Fire Risk Assessment

2 Dunston Road

Version 9

12 August 2024

AOV operating smoke detector Audibility

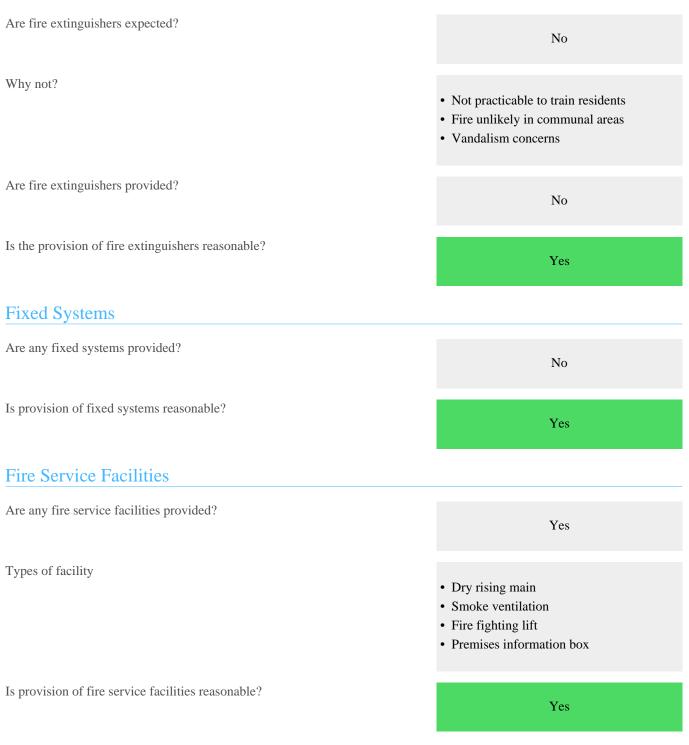
As part of this Type 3 Fire Risk Assessment access was gained into a sample flat to assess the provision and suitability of fire alarms.

Access was gained into flat 13 which has a fire alarm provided to BS5839-6 LD2 standard.
